Access Compliance Report

Public Rights-of-Way (Curb Ramps)

Intersection ID: 5763	Main Street: RICHFIELD_LN	Cross Street: STATESVILLE_RD	Location: SW
ADA ID: F49F525ABDC3	Ramp Type: Directional1	Initial Pass/Fail: Fail	Overall Compliance: No
Severity Score: 1.25			
Codes/Mitigation Info/Possible Solution		Field Measurements/Component Compliance

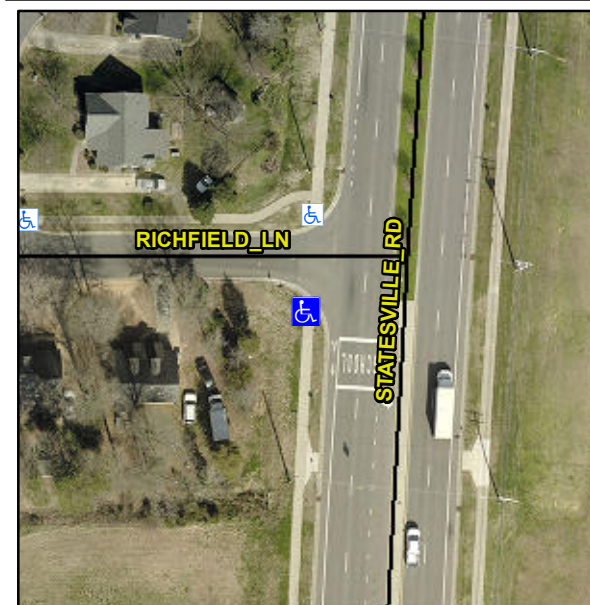
R304.5.3

Compliance	Description	Data	Compliance	Description	Data
N/A	Ramp Length (in)	86.0	N/A	Grade Break?	N/A
Yes	Ramp Width (in)	69.0	N/A	Grade Break Slope (%)	0.0
Yes	Ramp Slope (%)	7.5	N/A	Grade Break XSlope (%)	0.0
No	Ramp XSlope (%)	4.4			
N/A	Flare Type LT	N/A	N/A	Flare Type RT	N/A
N/A	Flare Slope LT (%)	N/A	N/A	Flare Slope RT (%)	0.0
N/A	Flare Traversable LT?	N/A	N/A	Flare Traversable RT?	N/A
N/A	Landing Length (in)	0.0	N/A	DWS Provided?	N/A
N/A	Landing Width (in)	0.0	N/A	DWS Contrast?	N/A
N/A	Landing Slope (%)	0.0	N/A	DWS Length (in)	N/A
N/A	Landing X Slope (%)	0.0	N/A	DWS Full Width?	N/A
N/A	Landing Curb? (Y/N)	N/A	N/A	DWS Offset LT (in)	N/A
N/A	Shared Landing?	N/A	N/A	DWS Offset RT (in)	N/A
N/A	Gutter Ponding?	0.0	N/A	Gutter Slope (%)	N/A
N/A	Gutter Lip Ht (in)	0.0	N/A	Gutter X Slope (%)	N/A
N/A	Painted X Walk1?	No		Road Slope (%)	0.1
	X Walk 1 Direction	To N		Road X Slope (%)	2.1
	X Walk 1 Width (in)	N/A		Clear Space?	N/A

Remove & Replace Entire Ramp.
